HISTORIC AND DESIGN REVIEW COMMISSION

August 07, 2024

HDRC CASE NO: 2024-229
ADDRESS: 1514 W LYNWOOD
LEGAL DESCRIPTION: NCB 2759 BLK 65 LOT 11
ZONING: R-4, H
CITY COUNCIL DIST.: 1
DISTRICT: Keystone Park Historic District
APPLICANT: ELENA ANGELES SANCHEZ/MOVEHOUSE INVESTMENT CORP
OWNER: ELENA ANGELES SANCHEZ/MOVEHOUSE INVESTMENT CORP
TYPE OF WORK: Demolition of a historic landmark (accessory) and front porch column modifications
APPLICATION RECEIVED: May 30, 2024
60-DAY REVIEW: September 27, 2024
CASE MANAGER: Rachel Rettaliata

1. Demolish the rear accessory structure.
2. Replace the existing metal front porch columns on the primary structure with wood columns.

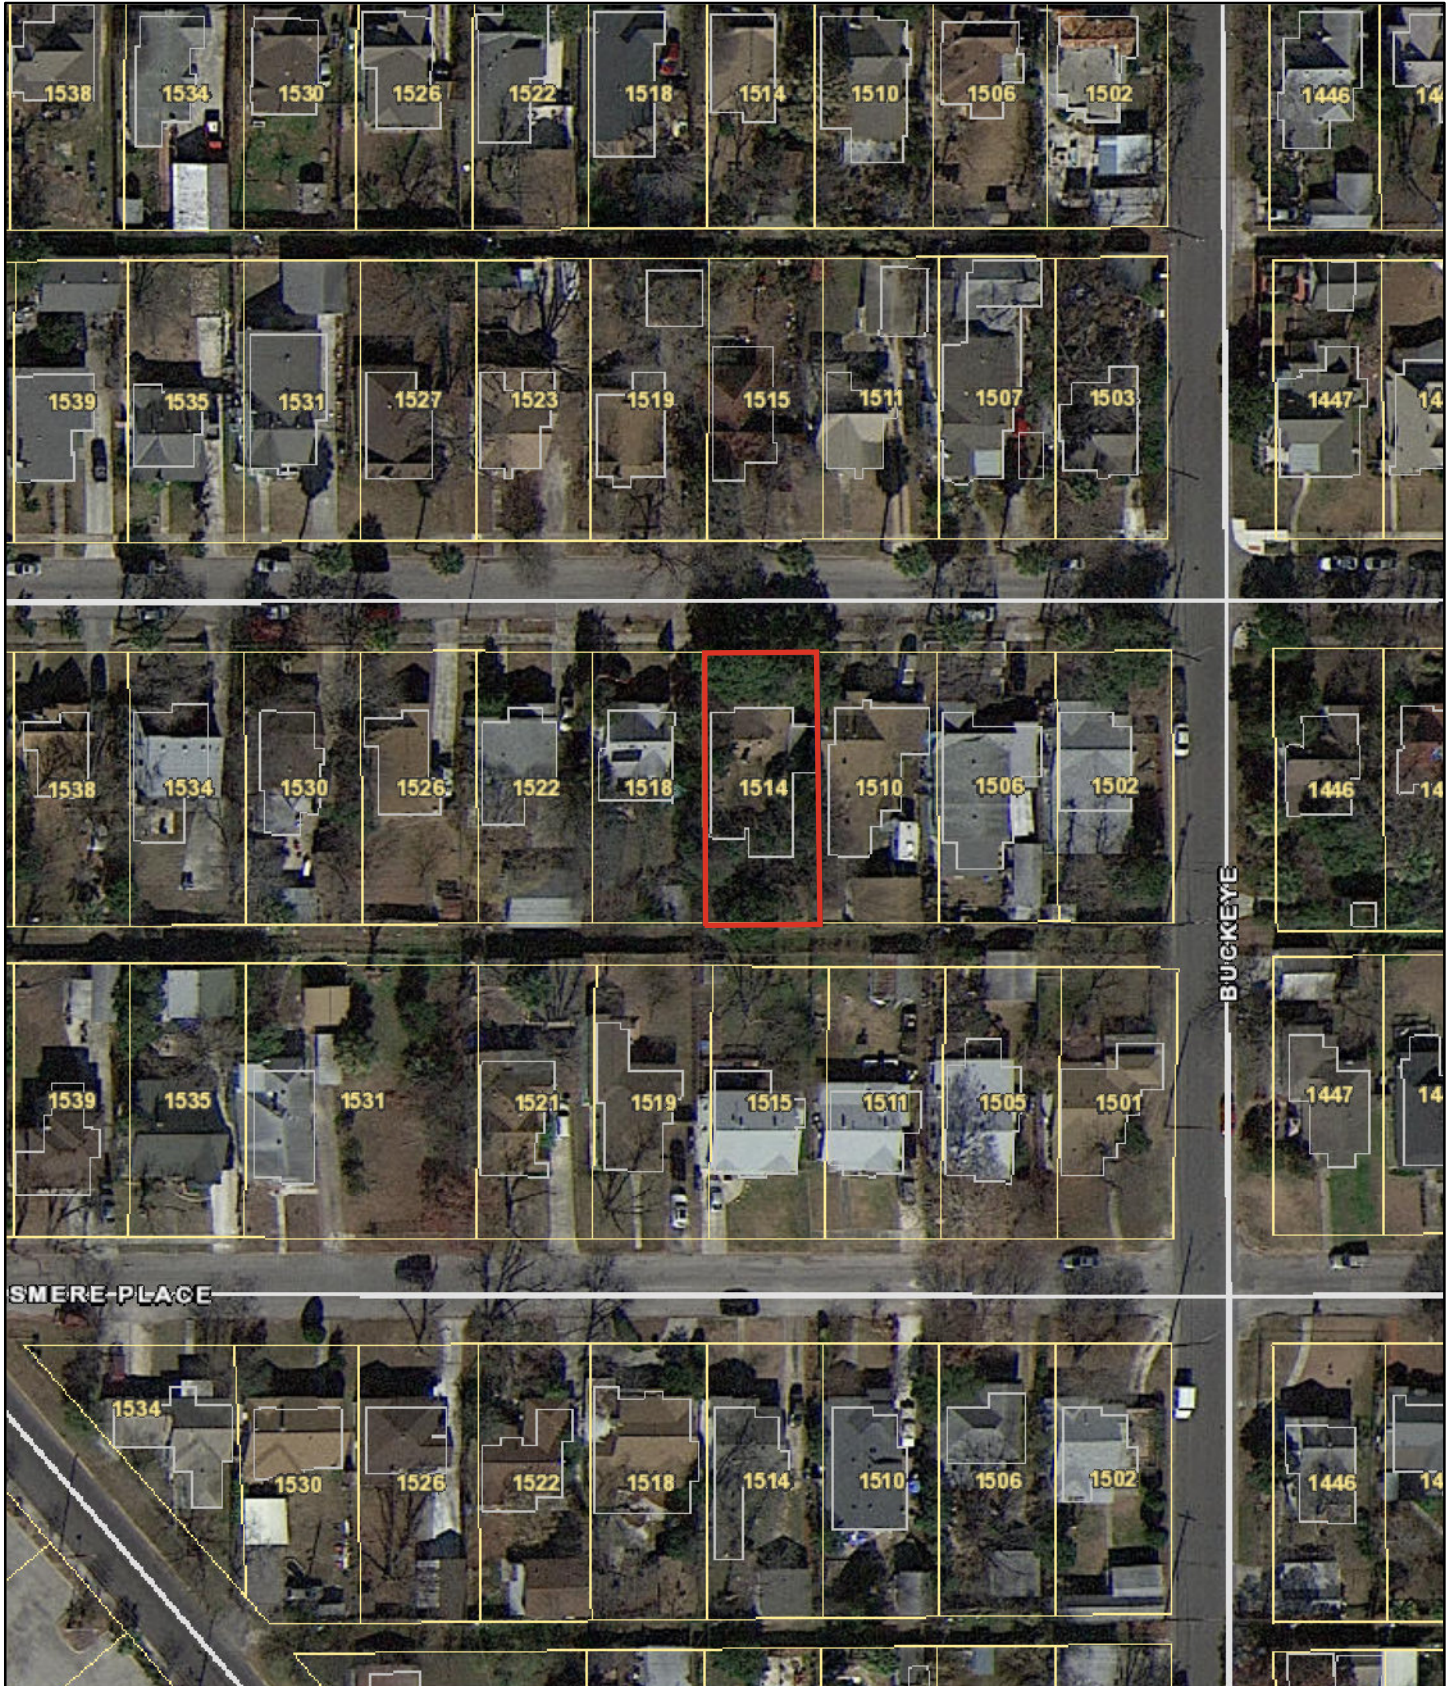
- h. **FRONT PORCH COLUMN REPLACEMENT** – The applicant has proposed to replace four (4) non-original decorative metal front porch columns with two (2) square wood columns installed flush with the front façade at the outer corners on the inset front porch. Guideline 7.B.iii for Exterior Maintenance and Alterations states that porches and related elements should be replaced in-kind when such features are deteriorated beyond repair. When in-kind replacement is not feasible, the design should be compatible in scale, massing, and details. Additionally, Guideline 7.B.iv for Exterior Maintenance and Alterations states that replacement elements should be designed to be simple so as to not distract from the historic character of the building. Do not add new elements and details to create a false historic appearance. Simple wood columns are appropriate for the architectural style of the structure; however, staff finds that columns should be more centrally located along the awning of the porch in a location that columns were traditionally installed on historic homes, similar to the locations of the previous decorative metal replacement columns. Installing square wood columns with a capital and base and chamfered corners in the approximate location of the previous metal columns would be appropriate.

Item 2, staff recommends approval of the replacement of the front porch columns based on finding h with the following stipulation:

- i. That the applicant installs fully wood front porch columns that are no wider than 6" square, featuring both capital and base trim and chamfered corners, in the approximate location of the previously existing metal columns. Updated material specifications and an updated elevation drawing must be submitted to staff for review and approval prior to the issuance of a Certificate of Appropriateness.

FOTO DEL GARAJE ACTUAL

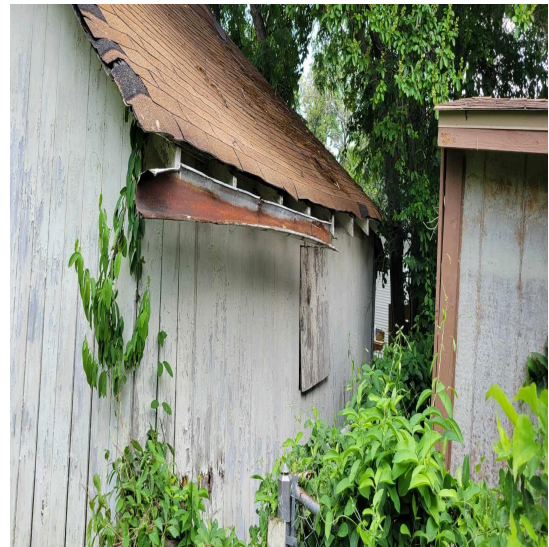
- b. **DEMOLITION OF REAR ACCESSORY STRUCTURE** – The applicant is requesting approval for the demolition of the rear accessory structure only. In general, accessory structures contribute to the character of historic properties and the historical development pattern within a historic district.

- e. **LOSS OF SIGNIFICANCE** – In accordance with UDC Section 35-614(c), demolition may be recommended if the owner has provided sufficient evidence to support a finding that the structure has undergone significant and irreversible changes which have caused it to lose historic, cultural, architectural, or archaeological significance, qualities or features which qualified the structure or property for such designation. The 1-story rear accessory structure features a front gable composition shingle roof, exposed rafter tails, vertical wood siding, and carriage style garage doors. There are no existing windows in the window openings. The structure is likely original to the property and the Sanborn Maps show that the property featured a rear accessory structure in the same location and footprint as the existing structure in 1934. Staff finds that the existing structure has significantly deteriorated.

Item 1, staff recommends approval of the demolition of the rear accessory structure based on findings a through g. This structure is subject to the City's deconstruction ordinance and a Certified Deconstruction Contractor must complete deconstruction, form submission, and permitting in accordance with UDC Chapter 12, Article II, as noted in finding g.
